# Access Audit Site Report

**Abilene State Park**

**Accessibility Evaluation**

**Inspection Date: 12/14/2021**

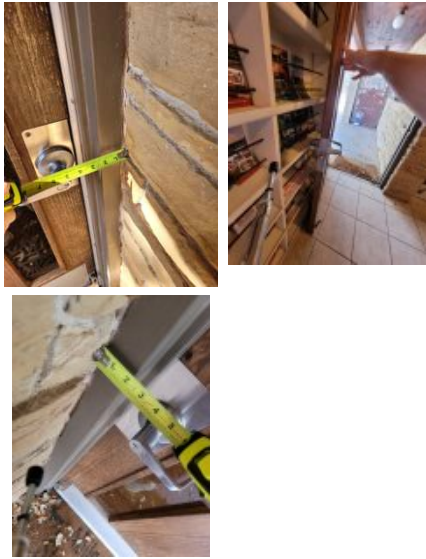
Finding Number	Area Description	Lat/Long	Finding	As Built	Recommendation	Citation	Photos	Figure
13	Exterior: Exterior Accessible Route	[32.2367253, -99.8777301]	There is a gap spaced greater than a 1/2 inch. Openings in floor or ground surfaces shall not allow passage of a sphere more than 1/2 inch diameter. Elongated openings shall be placed so that the long dimension is perpendicular to the dominant direction of travel.	4" gap at Star restroom, women's side	Correct or fill gaps to be max .5".	2015 ABAAS Section: 302.3 2012 TAS Section: 302.3 2010 ADAS Section: 302.3		
14	Exterior: Exterior Accessible Route	[32.236731, -99.877714]	There is a gap spaced greater than a 1/2 inch. Openings in floor or ground surfaces shall not allow passage of a sphere more than 1/2 inch diameter. Elongated openings shall be placed so that the long dimension is perpendicular to the dominant direction of travel.	Lacks AR to Star restroom due to 10" of grass	Correct or fill gaps to be max .5".	2015 ABAAS Section: 302.3 2012 TAS Section: 302.3 2010 ADAS Section: 302.3

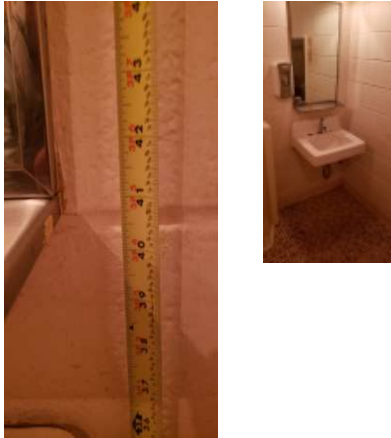
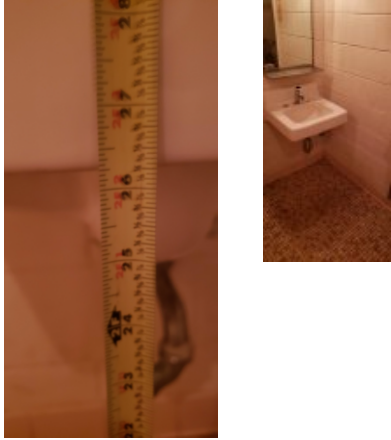
22	Headquarters : Employee Spaces	[32.2406434 , -99.879075 2]	The route of travel at this location does not provide a minimum width of 36 inches. The clear width shall be permitted to be reduced to 32 inches minimum for a length of 24 inches maximum provided that reduced width segments are separated by segments that are 48 inches long minimum and 36 inches wide minimum.	HQ break room - 30" width at entry, 16" due to storage	Widen doorway to min. 36" for recessed door and relocate storage.	2015 ABAAS Section: 403.5.1  2012 TAS Section: 403.5.1  2010 ADAS Section: 403.5.1	   	
23	Headquarters : Employee Spaces	[32.2406468 , -99.879081 9]	The edges of the carpet are not fastened and/or are exposed without trim. Carpet or carpet tile shall be securely attached and shall have a firm cushion, pad, or backing or no cushion or pad. Carpet or carpet tile shall have a level loop, textured loop, level cut pile, or level cut/uncut pile texture. Pile height shall be 1/2 inch maximum. Exposed edges of carpet shall be fastened to floor surfaces and shall have trim on the entire length of the exposed edge.	Lacks secure floor mat	Secure edges of carpeting or mats to prevent trip hazard.	2015 ABAAS Section: 302.2  2012 TAS Section: 302.2  2010 ADAS Section: 302.2

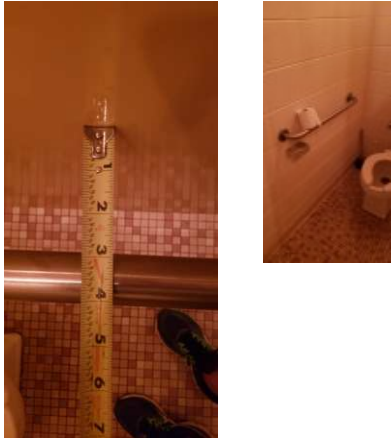
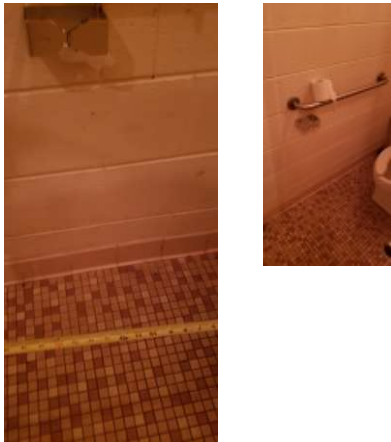
Finding Number	Area Description	Lat/Long	Finding	As Built	Recommendation	Citation	Photos	Figure
28	Headquarters : Public Spaces	[32.240606, -99.879060 4]	The top merchandise, brochure rack and hand sanitizer are positioned too high for either a side or front approach. Where a clear floor or ground space allows a parallel approach to an element and the side reach is unobstructed, the high side reach shall be 48 inches maximum and the low side reach shall be 15 inches minimum above the finish floor or ground. Where a forward reach is unobstructed, the high forward reach shall be 48 inches maximum and the low forward reach shall be 15 inches minimum above the finish floor or ground.	Top shelf of merchandise at 60" AFF, top brochures at 75" AFF, and hand sanitizer at 54" AFF	Relocate or remount operable parts to be in reach range of 15" min to 48" max.	2015 ABAAS Section: 308.1  2012 TAS Section: 308.1  2010 ADAS Section: 308.1

29	Headquarters : Public Spaces	[32.2406264, -99.879087 3]	The there is no lower drinking fountain meeting the requirements for persons using wheelchairs. Spout outlets of the lower bowl drinking fountains shall be 36 inches maximum above the finish floor or ground. Lower bowl drinking fountains shall provide knee and toe clearance centered on the unit.	Lacks low bowl - spout at 39" AFF	Add second low bowl fountain for persons using wheelchairs.	2015 ABAAS Section: 602.4  2012 TAS Section: 602.4  2010 ADAS Section: 211.2

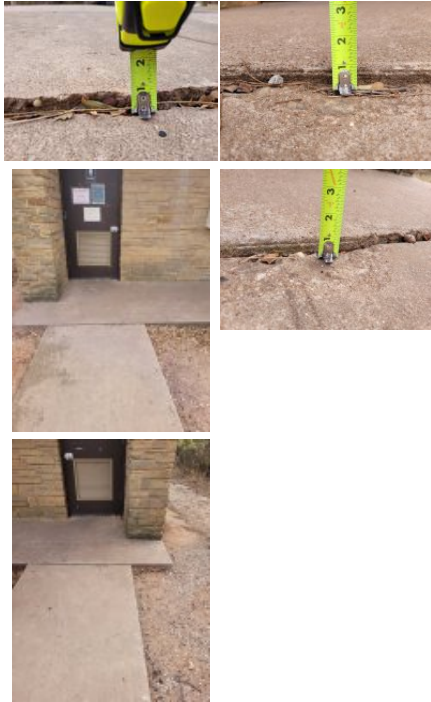
Finding Number	Area Description	Lat/Long	Finding	As Built	Recommendation	Citation	Photos	Figure
36	Headquarters : Headquarters Restroom	[32.2406332 , -99.879060 4]	The ambulatory stall is not between 35" to 37" wide and 60" deep.	Ambulatory stall is 56" deep	Correct ambulatory stall to be 35" to 37" wide and minimum 60" deep. In the alternative, use existing ambulatory stall to create required wheelchair accessible stall.	2015 ABAAS Section: 604.8.2.1  2012 TAS Section: 604.8.2.1  2010 ADAS Section: 604.8.2.1		
37	Headquarters : Headquarters Restroom	[32.240623, -99.879080 5]	The stall door fails to comply with all of the door requirements. The stall door must be a minimum of 32" wide and have compliant hardware on both sides. The stall door must be self-closing.	Ambulatory stall door is not self-closing and 30" wide	Widen stall doors to 32" when opened to 90 degrees. Adjust stall door to be self-closing.	2015 ABAAS Section: 404.2.3, 404.2.7, 604.8.2.2  2012 TAS Section: 404.2.3, 404.2.7, 604.8.2.2  2010 ADAS Section: 404.2.3, 404.2.7, 604.8.2.2

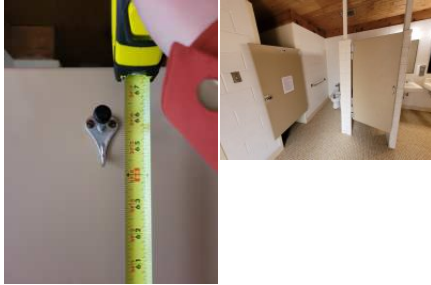
Finding Number	Area Description	Lat/Long	Finding	As Built	Recommendation	Citation	Photos	Figure
44	Headquarters : Headquarters Restroom	[32.240615, -99.879092 6]	Minimum maneuvering clearances at doors and gates shall comply with 404.2.4. Maneuvering clearances shall extend the full width of the doorway and the required latch side or hinge side clearance. All interior doors must be maintained so that the operating pressure does not exceed 5 lb. force to open. The sweep period for doors with closers shall be adjusted so that from an open position of 70 degrees, the door will take at least 3 seconds to move to a point 3 inches from the latch, measured to the leading edge of the door.	Door - wall in pull side clearance, more than 5# push, fast close	For all doors along the public circulation route, provide required maneuvering clearance on push and pull side of doors. For all doors along the public circulation route, inspect, adjust, and maintain 5 lbf to open interior doors. For all doors along the public circulation route, inspect, adjust, and maintain closing speed on door closers.	2010 ADAS Section: 404.2.3, 404.2.7, 404.2.4, 404.2.11, 404.2.11 Exception

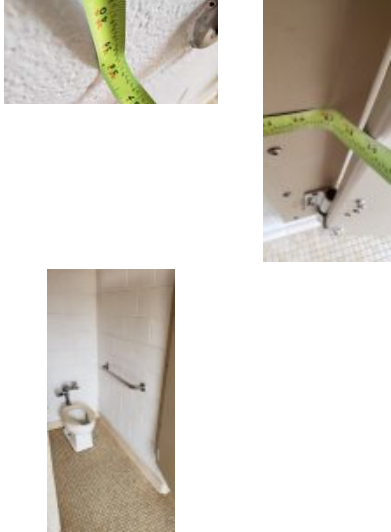
61	Pecan Grove: Pecan Grove - Women's Restroom	[32.235819, -99.880498 1]	The heater extends down too close to the route of travel. Any obstruction that overhangs a route of travel must be a minimum of 80 inches above the walking surface as measured from the bottom of the obstruction.	Women's - Heater at 73" AFF	Raise heater to min 80", or pad object to prevent hazard in overhead clearance along AR.	2015 ABAAS Section: 307.4  2012 TAS Section: 307.4  2010 ADAS Section: 307.4		
62	Pecan Grove: Pecan Grove - Women's Restroom	[32.2331599 , -99.884896 9]	The hand dryer projects more than 4 inches into the circulation path. Wall-mounted objects that have leading edges between 27 inches and 80 inches from the floor must not project more than 4 inches into the circulation path. Protruding objects that extend to the floor or within 27 inches of the floor are cane detectable and are therefore not hazardous. Where it is necessary or desirable to have objects protrude from the wall, a manner of cane detection must be provided.	Women's - Hand dryer projects 8"	Relocate protruding objects or place cane detectable warning or bollard at foot of item.	2015 ABAAS Section: 307.2  2012 TAS Section: 307.2  2010 ADAS Section: 307.2

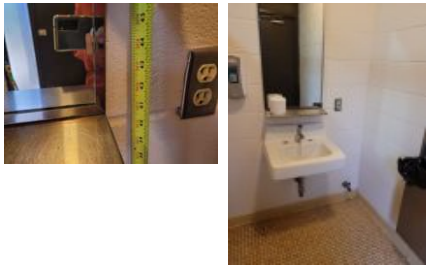
85	Oak Grove: Parking and Exterior Accessible Route	[32.2365824, -99.8813698]	There is a gap spaced greater than a 1/2 inch. Openings in floor or ground surfaces shall not allow passage of a sphere more than 1/2 inch diameter. Elongated openings shall be placed so that the long dimension is perpendicular to the dominant direction of travel.	1" gap at entry to group hall by yurt	Correct or fill gaps to be max .5".	2015 ABAAS Section: 302.3 2012 TAS Section: 302.3 2010 ADAS Section: 302.3

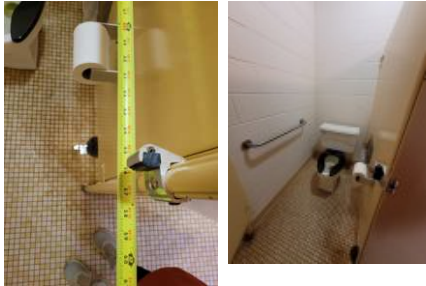
Finding Number	Area Description	Lat/Long	Finding	As Built	Recommendation	Citation	Photos	Figure
89	Oak Grove: Parking and Exterior Accessible Route	[32.2366153 , -99.881396 6]	The running slope of walking surfaces shall not be steeper than 1:20.	Entry to group shelter by yurts - Slopes of 5.9% at left fork, 6.1% at right fork	Correct running slope along the AR to max 5%.	2015 ABAAS Section: 403.3  2012 TAS Section: 403.3  2010 ADAS Section: 403.3

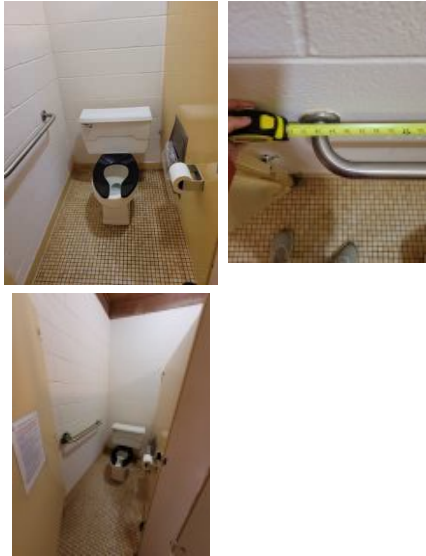
91	Oak Grove: Parking and Exterior Accessible Route	[32.2358371 , -99.880524 9]	The water flow from the spout is too low. The spout shall provide a flow of water 4 inches high minimum.	Drinking fountain inoperable, unable to test	Adjust spout flow height to min 4".	2015 ABAAS Section: 602.6  2012 TAS Section: 602.6  2010 ADAS Section: 602.6

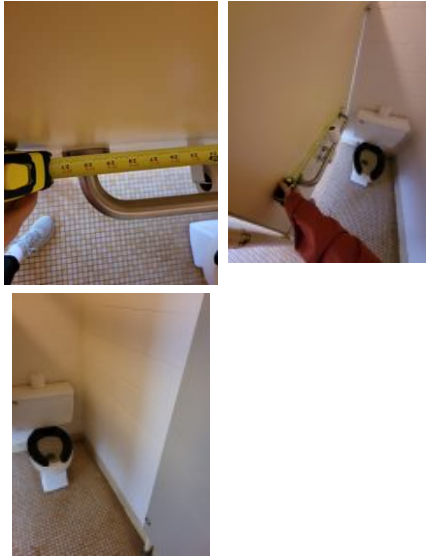
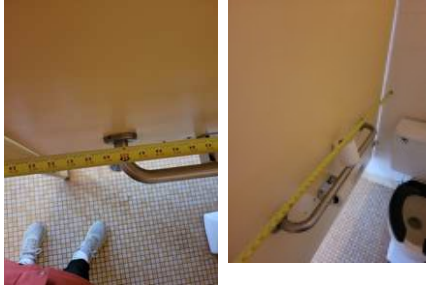
97	Oak Grove: Group Hall by Yurts - Women's Restroom	[32.2367083 , -99.881426 1]	The ambulatory stall is not between 35" to 37" wide and 60" deep.	Ambulatory stall is 37" by 56"	Correct ambulatory stall to be 35" to 37" wide and minimum 60" deep. In the alternative, use existing ambulatory stall to create required wheelchair accessible stall.	2015 ABAAS Section: 604.8.2.1 2012 TAS Section: 604.8.2.1 2010 ADAS Section: 604.8.2.1

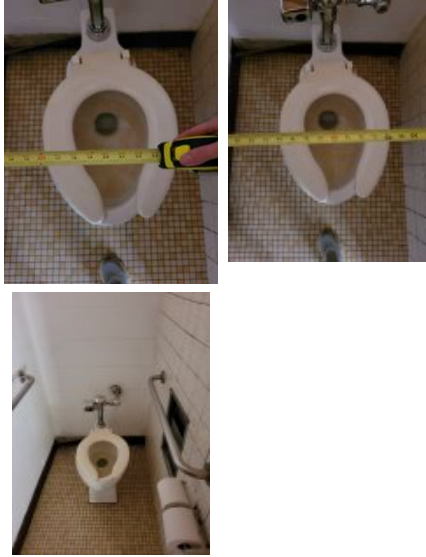
147	Cedar Grove: Parking and Exterior Accessible Route	[32.2379766 , -99.878683 6]	The route of travel at this location does not provide the required minimum width. The minimum clear width for sidewalks and walks is 36 inches.	35.25" width around Cedar Grove restroom building	Widen EAR to min 36" clear width.	2015 ABAAS Section: 403.5.1 2012 TAS Section: 403.5.1 2010 ADAS Section: 403.5.1

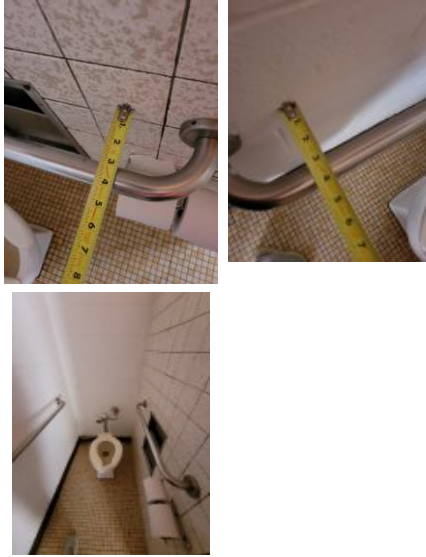
149	Cedar Grove: Cedar Grove - Women's Restroom	[32.2380242 , -99.878749 3]	The tactile restroom wall sign is missing the International Symbol of Accessibility (ISA). Accessible toilet rooms or bathing rooms shall be identified by the International Symbol of Accessibility (ISA). Wall signs identifying permanent rooms and spaces of a building shall have be horizontal format and the characters raised 1/32 inch minimum and shall be sans serif uppercase characters a minimum of 5/8 inch and a maximum of 2 inches high. Contracted Grade 2 Braille shall be in a horizontal format and shall be placed a minimum of 3/8 inch and a maximum of 1/2 inch directly below the tactile characters; flush left or centered. Signs with raised characters or Braille shall be located 48 inches minimum above the finish floor or ground surface, measured from the baseline of the lowest tactile character and 60 inches maximum above the finish floor or ground surface, measured from the baseline of the highest tactile character.	Lacks ISA	Acquire and mount signage, including access symbol. Acquire and mount signage, including Braille and access symbol mounted on wall, latch side of door, 48" to baseline of lowest character and 60" to baseline of highest character.	2015 ABAAS Section: F216.8 2012 TAS Section: 216.8 2010 ADAS Section: 216.8

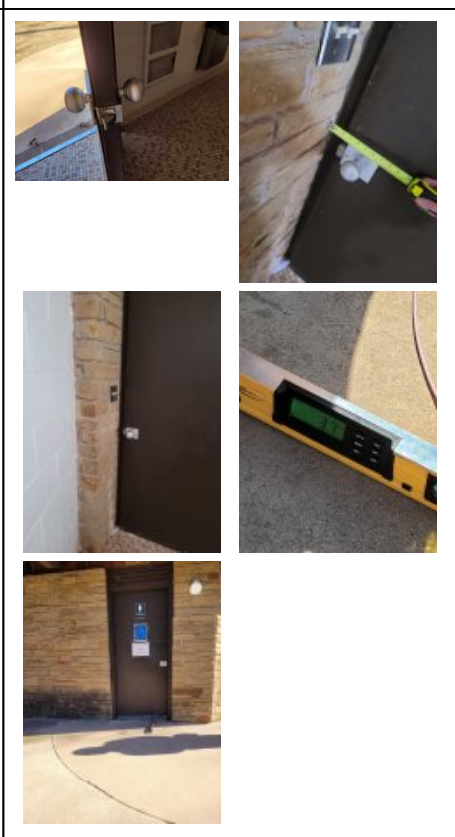
193	Wagon Circle: Dining Hall - Women's Restroom	[32.23755, -99.8834646]	The water and drain pipes under the lavatory are not adequately insulated. Water supply and drain pipes under lavatories and sinks shall be insulated or otherwise configured to protect against contact. There shall be no sharp or abrasive surfaces under lavatories and sinks.	Sink lacks insulated pipes	Insulate exposed pipes under one sink.	2015 ABAAS Section: 606.5  2012 TAS Section: 606.5  2010 ADAS Section: 606.5

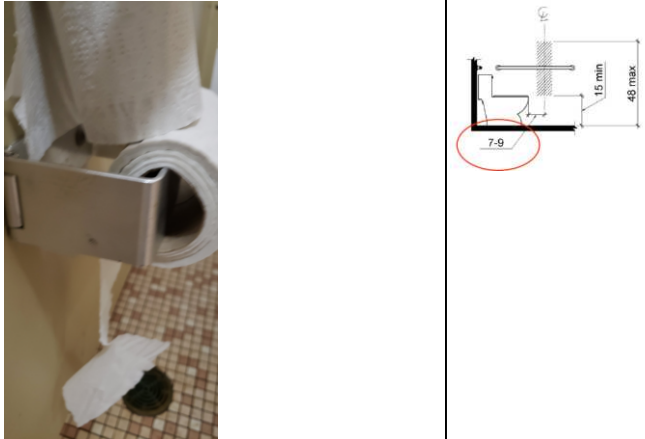
196	Wagon Circle: Dining Hall - Women's Restroom	[32.2375727, -99.8834727]	The ambulatory stall is not between 35" to 37" wide and 60" deep.	Ambulatory stall is 37" by 56"	Correct ambulatory stall to be 35" to 37" wide and minimum 60" deep. In the alternative, use existing ambulatory stall to create required wheelchair stall.	2015 ABAAS Section: 604.8.2.1 2012 TAS Section: 604.8.2.1 2010 ADAS Section: 604.8.2.1

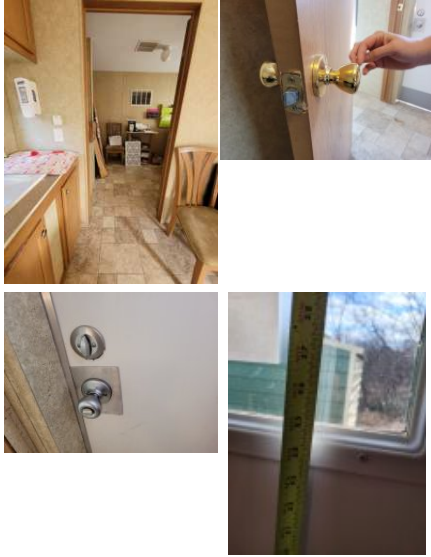
238	Park Site: Maintenance	[32.2406332 , -99.881141 8]	The restroom sign does not comply with one or more applicable requirements for the location, height, and properties of the sign.	Office across from residence - Restroom lacks any signage	Acquire and mount signage, including Braille and access symbol mounted on wall, latch side of door, 48" to baseline of lowest character and 60" to baseline of highest character.	2015 ABAAS Section: F216.2, 703.1, 703.2, 703.5, 703.6  2012 TAS Section: 216.2, 703.1, 703.2, 703.5, 703.6  2010 ADAS Section: 216.2, 703.1, 703.2, 703.5, 703.6

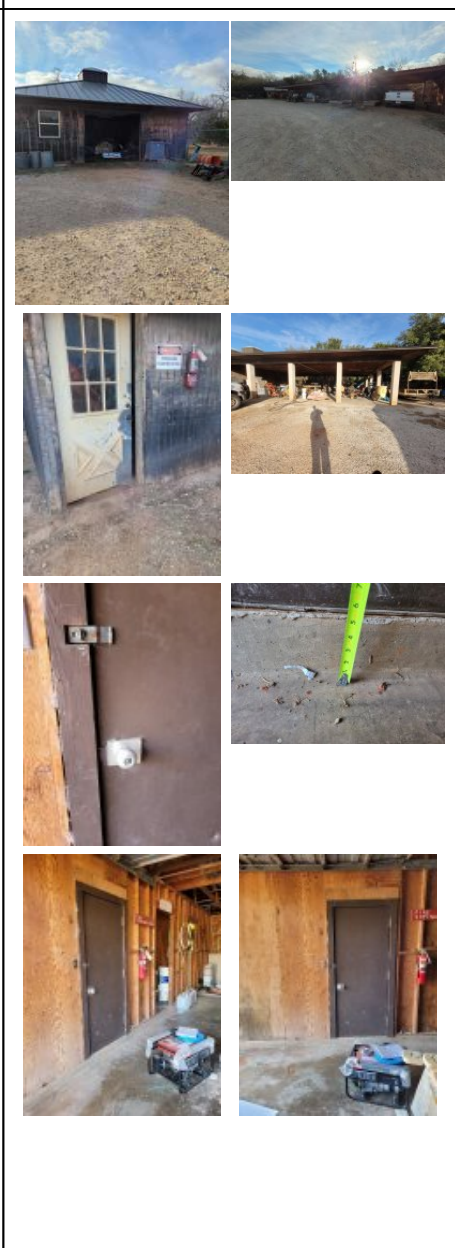
246	Park Site: Maintenance	[32.2405946, -99.881117 7]	The pass through kitchen is not wide enough. In pass through kitchens where counters, appliances or cabinets are on two opposing sides, or where counters, appliances or cabinets are opposite a parallel wall, clearance between all opposing base cabinets, counter tops, appliances, or walls within kitchen work areas shall be 40 inches minimum. Pass through kitchens shall have two entries.	Work space across from residence - chairs in kitchen obstruct 40" width	Remove objects to provide required 40" clearance through kitchen.	2015 ABAAS Section: 804.2.1  2012 TAS Section: 804.2.1  2010 ADAS Section: 804.2.1

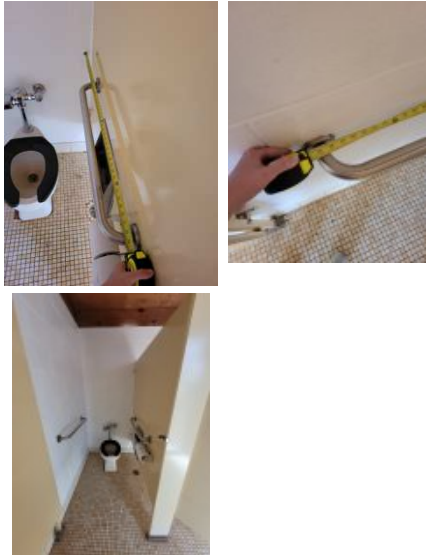
260	Restrooms: Boat Ramp Restrooms	[32.2322887 , -99.895148 3]	The operable part is positioned too high for either a side or front approach. Where a clear floor or ground space allows a parallel approach to an element and the side reach is unobstructed, the high side reach shall be 48 inches maximum and the low side reach shall be 15 inches minimum above the finish floor or ground. Where a forward reach is unobstructed, the high forward reach shall be 48 inches maximum and the low forward reach shall be 15 inches minimum above the finish floor or ground.	Hand sanitizer dispenser at 57" AFF	Remount operable parts to be in reach range of 15" min to 48" max.	2015 ABAAS Section: 308.1  2012 TAS Section: 308.1  2010 ADAS Section: 308.1

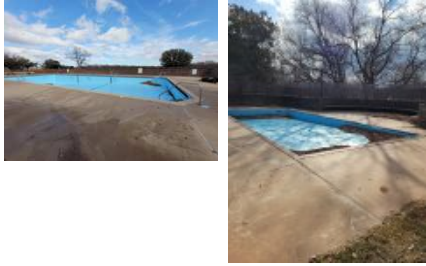
295	Swimming Pool: Pool/Deck	[32.2383475 , -99.8808749]	The transaction counter is too high. A portion of the counter surface that is 36 inches long minimum and 36 inches high maximum above the finish floor shall be provided. Knee and toe space must be provided for a forward approach. A 30 inch by 48 inch clear floor space on an accessible route must be provided for either a forward or parallel approach.	Entry counter at pool at 42" AFF	Lower 36" wide segment of service counter to max 36" AFF.	2015 ABAAS Section: 904.4.2, 904.4.1  2012 TAS Section: 904.4.1, 904.4.2  2010 ADAS Section: 904.4.2, 904.4.1

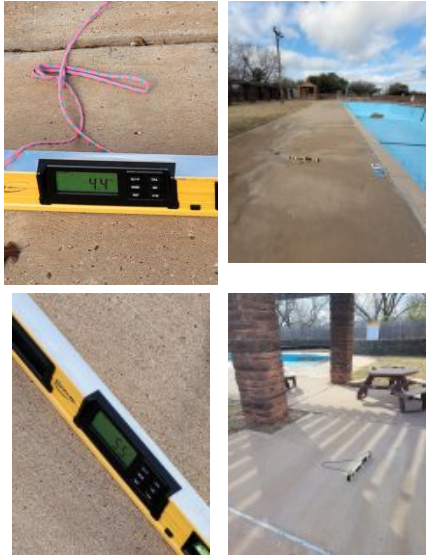
300	Swimming Pool: Pool/Deck	[32.2382329 , -99.880868 2]	The stair risers are not uniform in height. Stair riser heights shall be 7 inches maximum and 4 inches minimum. On any given flight of stairs, all steps shall have uniform riser height and uniform tread widths.	Viewing Deck - First step is 6" all rest are 7"	Correct riser heights on stairs to consistent height between 4" to 7".	2015 ABAAS Section: 504.2  2012 TAS Section: 504.2  2010 ADAS Section: 504.2
